The City of Grove City, Ohio

Staff has reviewed your development plan application for the Canaan Land Church Building Expansion located at 2777 Gantz Road. The control number for this application is #201506290047 and should be referenced on any future correspondence concerning this matter.

Canaan Land FWB Church

Response to Planning Commission Letter of July 15, 2015

LANDSCAPE PLAN
1"=40'-0"

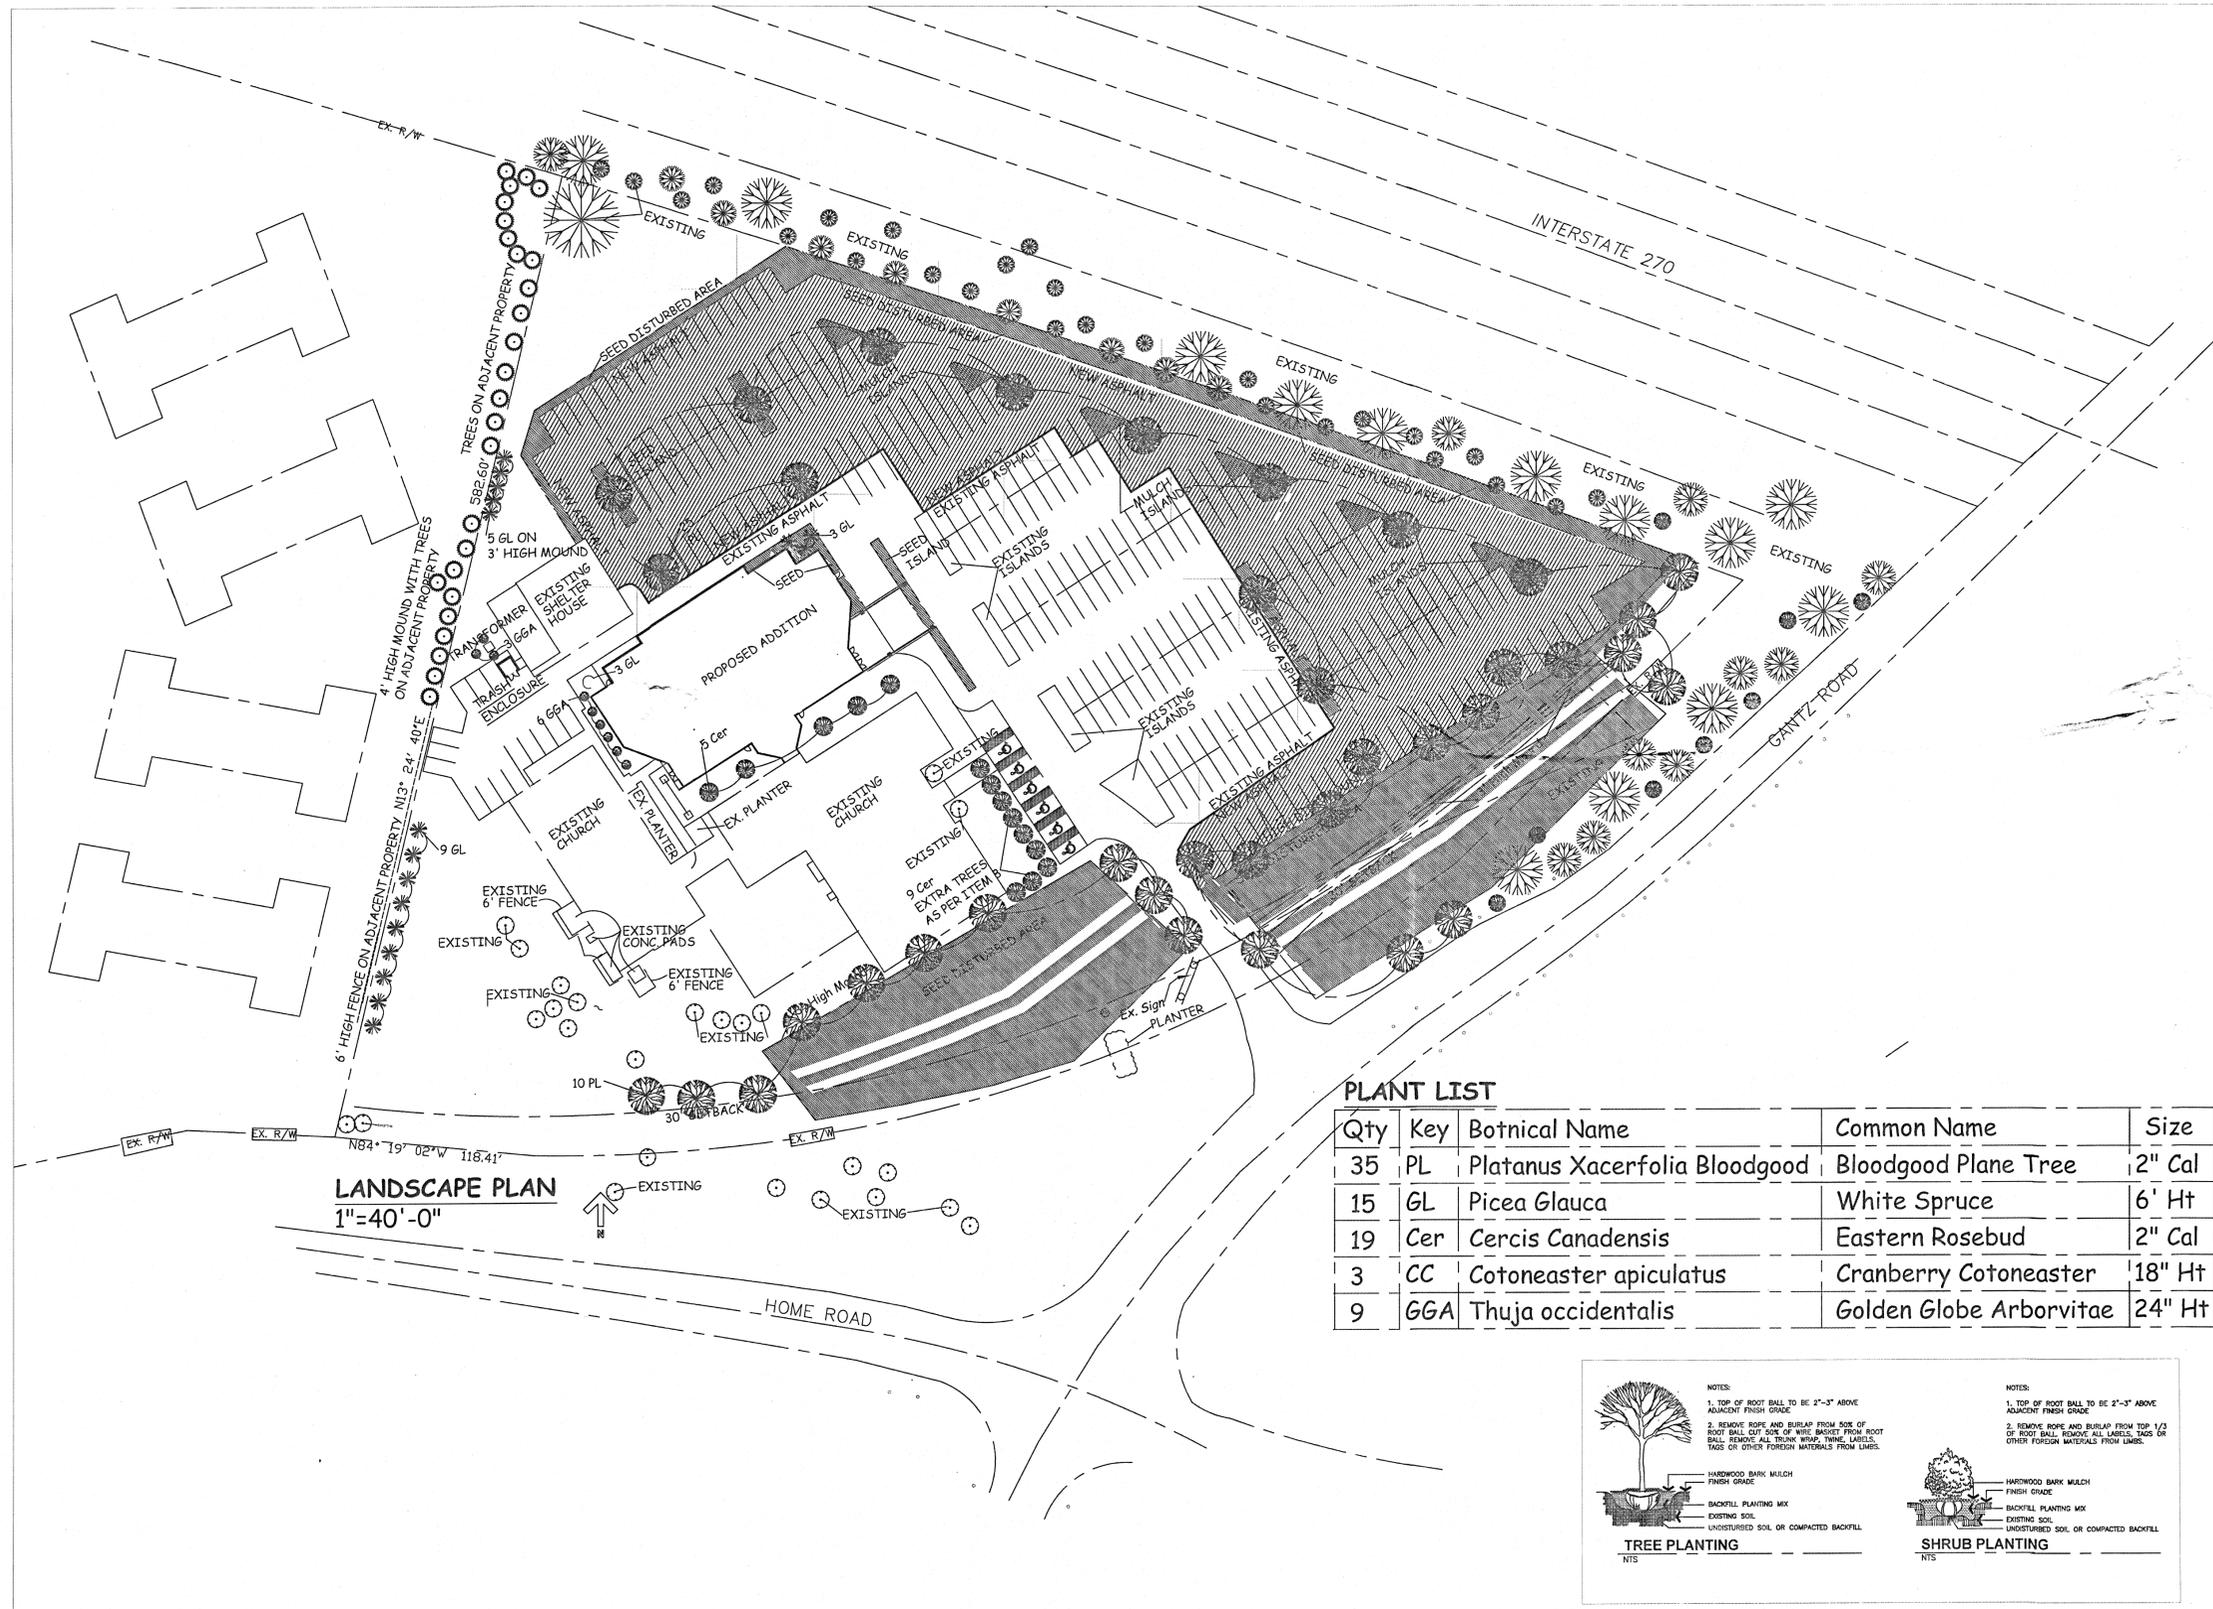
17. 1136.06(a) (c): Rear and Side Yards Adjacent Incompatible Use Districts: Between the parking lot and western property boundary (Village at Gantz Meadows), one of the following options:

18. 1136.06(d): Parking Lot Islands: City Code requires to have at least 9 island beds in the new parking lot addition based on the number of parking spaces being added; it appears from the plans that there needs to be a total of 22 island beds in the parking lot. Each island needs to have a 2" minimum caliper tree per island bed

19. 1136.09: Landscaping Abutting the Structure: City Code requires that there be one 2" minimum caliper tree planted per each 40 lineal feet of building perimeter. 6 trees are required in addition to 64 square feet minimum of landscape area. Trees should be arranged around all sides of the building.

20. 1136.10: Retention Pond Area: City Code requires that a 2" minimum caliper tree be planted in a landscape area for every 50 lineal feet of retention area. Retention area on west side of property would require 5 trees and the retention area on the east side would require 6 trees.

Option A that includes a 10 feet minimum parking set back with a continuous 3 feet high evergreen hedge will be planted along the parking area facing Gantz Road. This is shown on the landscape plan.

Option A described above has been incorporated into the landscape plan for this site.
